RI-0015

**IM-5006**

**MASTER SPEAKER NOISE REDUCTION**

## **IM-5006 NOISE REDUCTION**

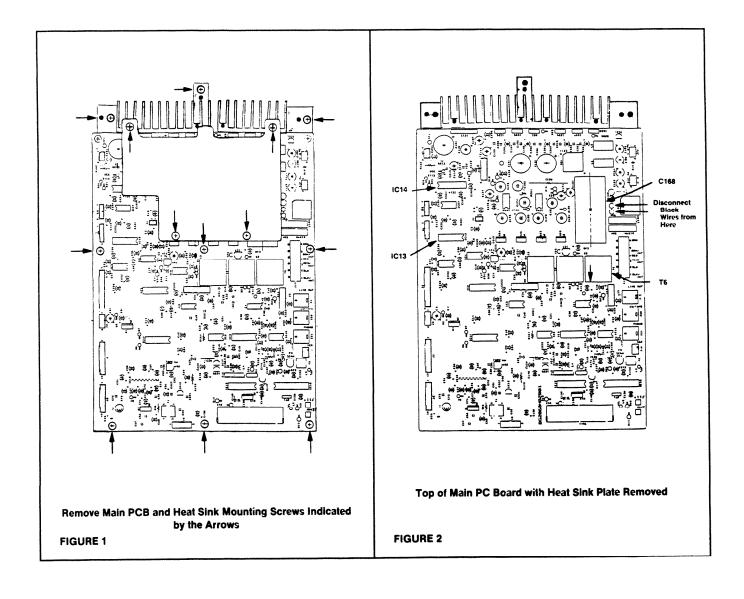
- 1. Remove front panel mounting screws and allow the unit to lay parallel with the floor.
- Disconnect main power from system by disconnecting low voltage AC supply wires from the transformers.
- 3. Remove main PC board and heat sink mounting screws indicated by the arrows on Figure 1.
- 4. Disconnect the green wire connected to the right hinge.
- 5. Disconnect the black wires located on the right side of the main PC board as illustrated in Figure 2.
- 6. Locate C168 and T6 on the main PC board (see Figure 2).

- 7. Once located, stand main PC board on its side so access to the back of the PC board is possible. Examine Figures 3 and 4 to locate the areas which will require desoldering.
- 8. Desolder and remove C168.
- 9. Desolder the secondary of T6 and angle T6 so the leads of the secondary are pulled out from the PC board as illustrated in Figure 5.

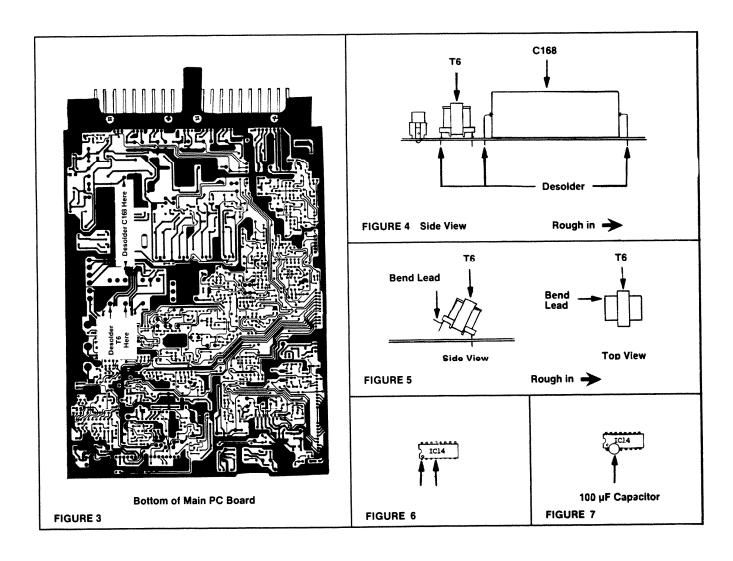
- 10. See Figure 5. Once T6 has been desoldered, locate the pin on the **LEFT** side of secondary and bend at a 90° angle away from the transformer.
- 11. After the pin on T6's secondary has been appropriately bent, install transformer back into mounting hole making sure the bent lead of the transformer does not come into contact with the PC board.
- 12. Solder a 5" piece of 22 gauge wire onto the bent pin of T6. Connect the other end of the wire to Pin 7 of IC13 as illustrated in Figure 8.

- 13. Install 22 gauge wire and heat shrink tubing onto Capacitor C168 as illustrated in Figure 9.
- 14. Install C168 through the bottom of the main PC board making sure the arrow on the capacitor is pointing away from the rough-in as shown on Figure 8.

- 15. Once installed, position C168 on the right side of the main PC board as illustrated on Figure 8.
- 16. Next locate Pins 1 and 4 on IC14 (Figures 2 and 6).

- 17. See Figure 7. Install 100μF capacitor between Pins 1 and 4 of IC14, connecting the negative lead of the capacitor to Pin 1.
- 18. Install heat sink plate. Install main PC board onto front panel. Attach green ground wire to the right hinge. Connect the black wires to the appropriate terminals on the main PC board.
